July 1, 2021

ADDENDUM No. 1

Oregon Central Fire Station

A8.5

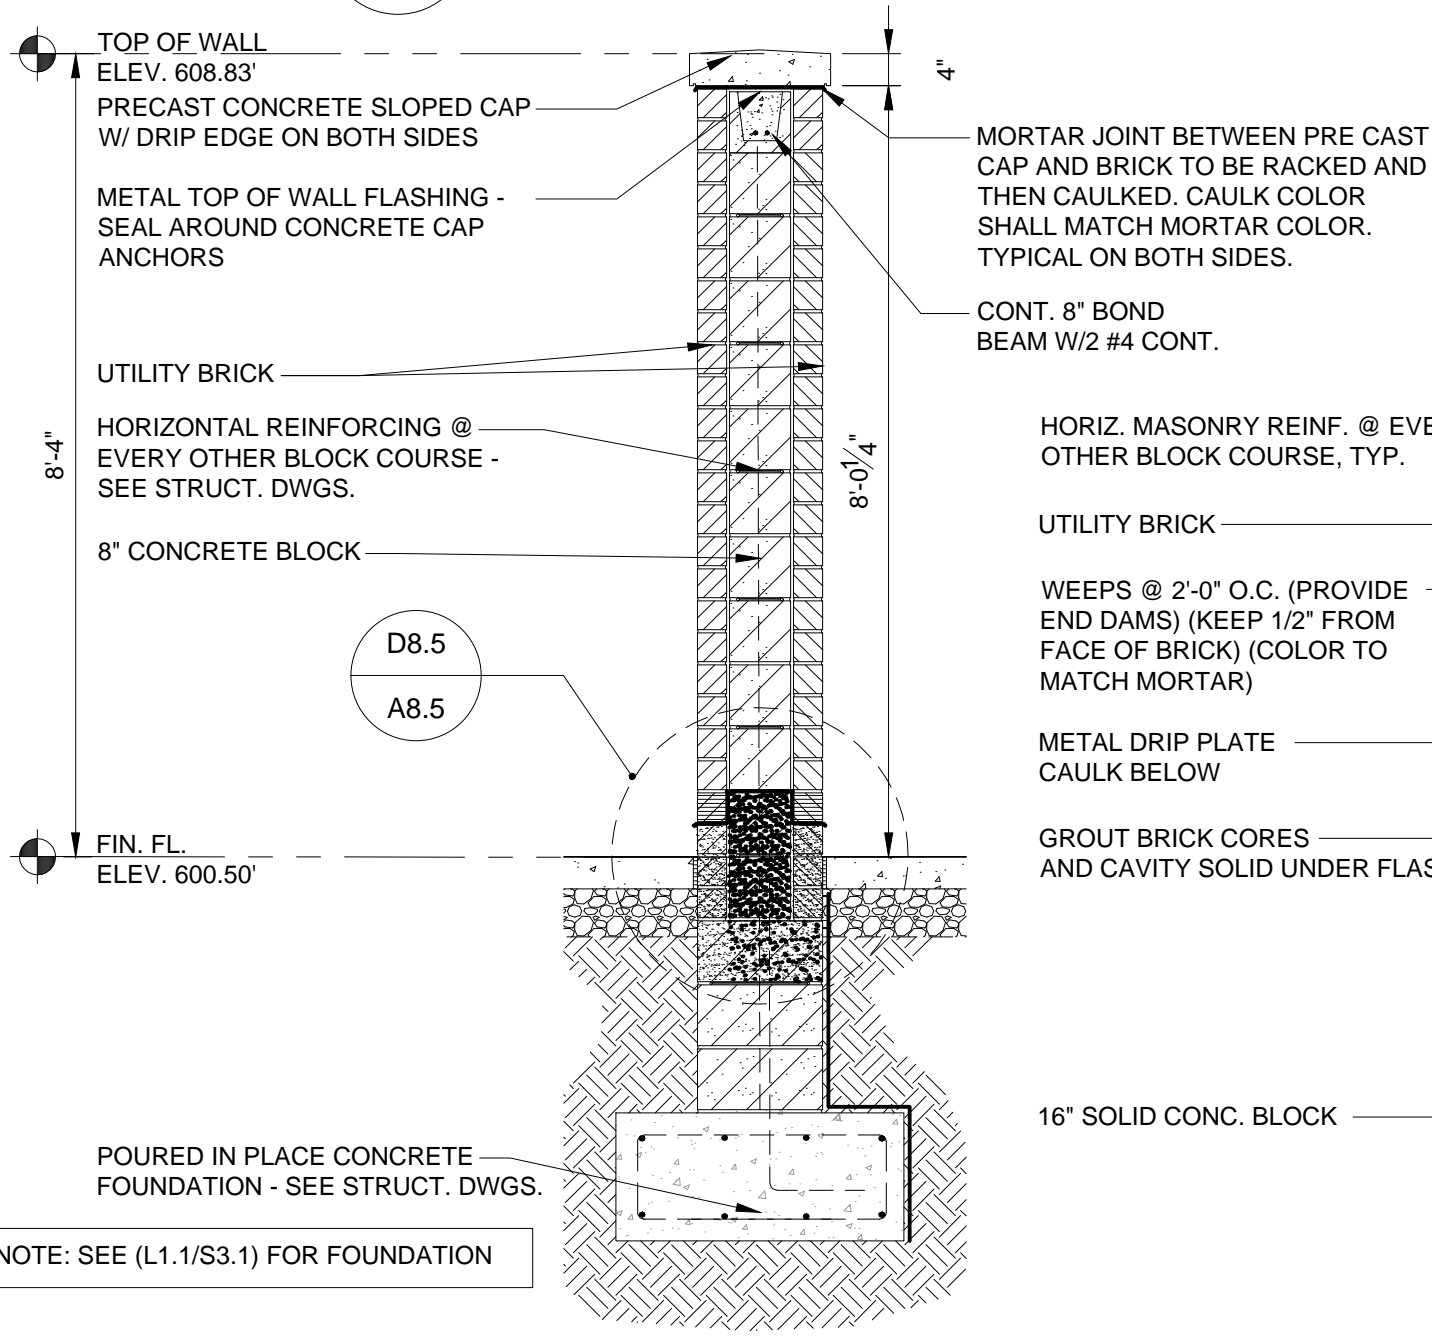
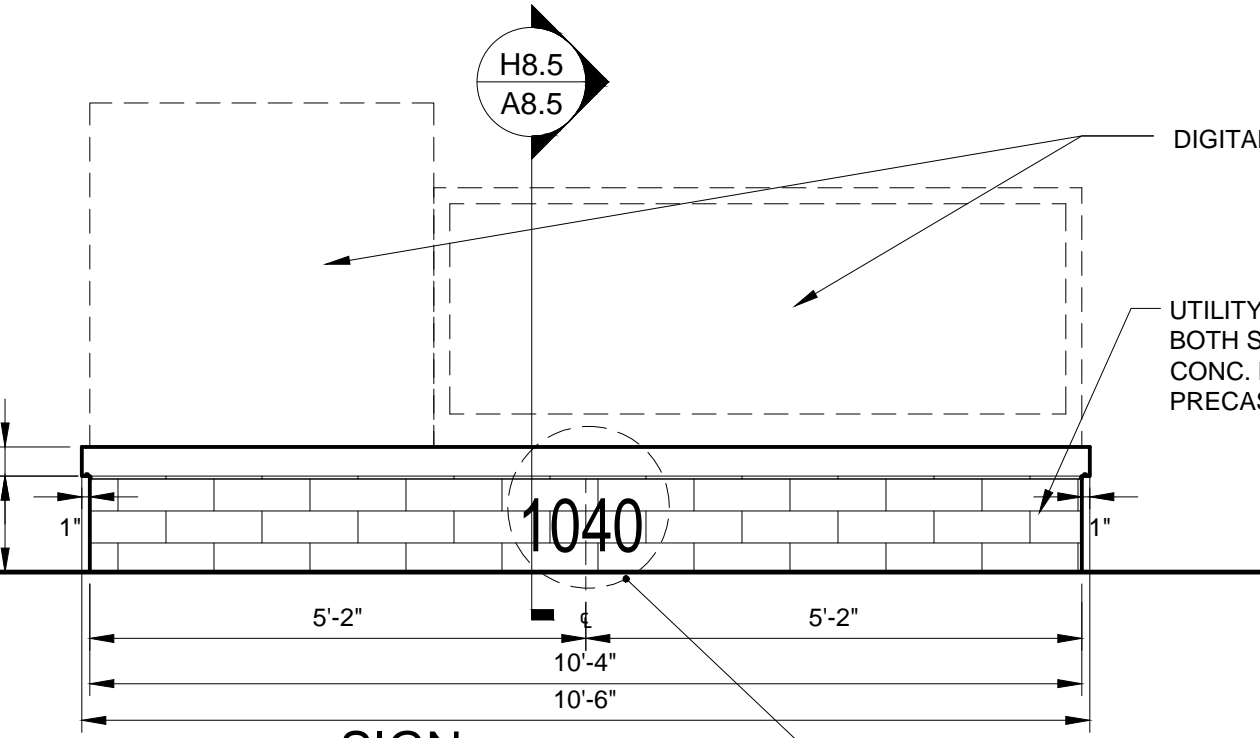
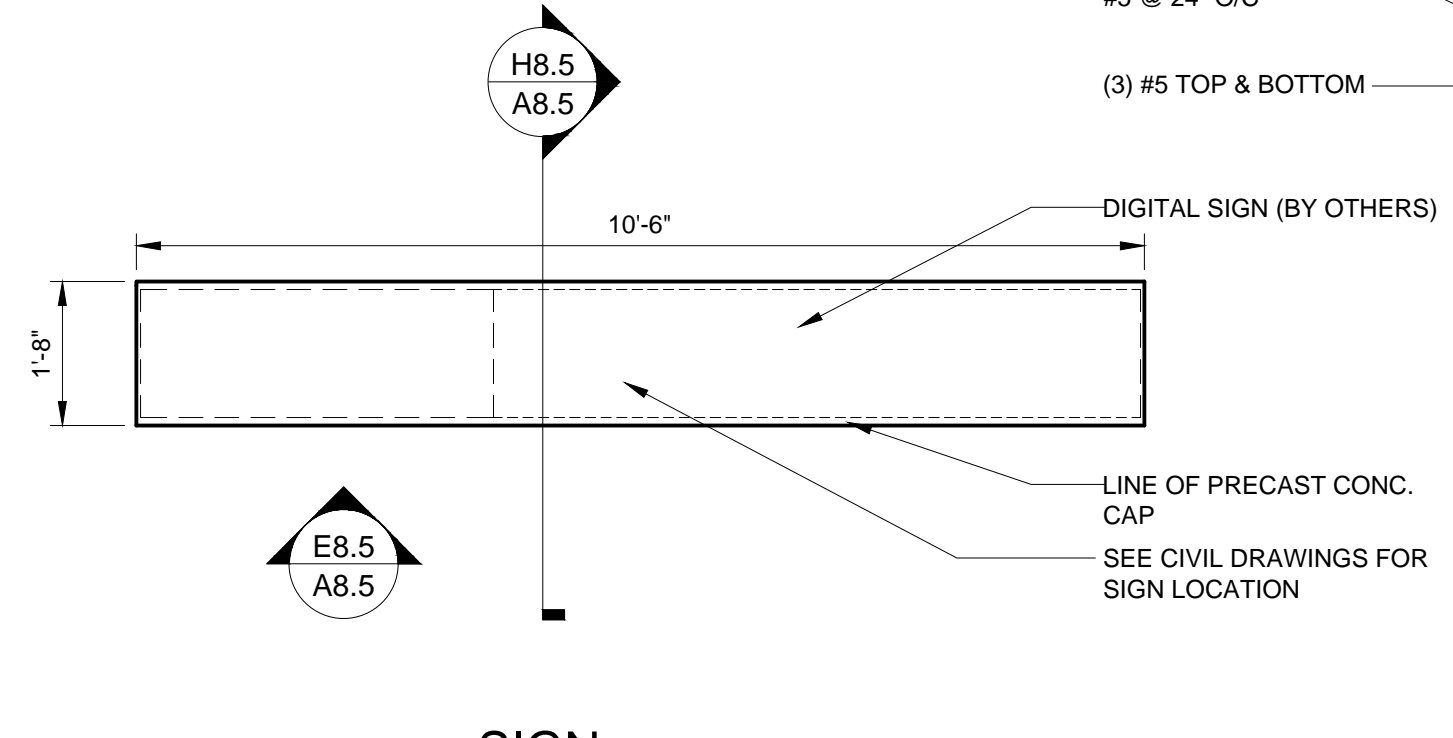
- See attached revised drawing A8.5 for revised digital sign details.
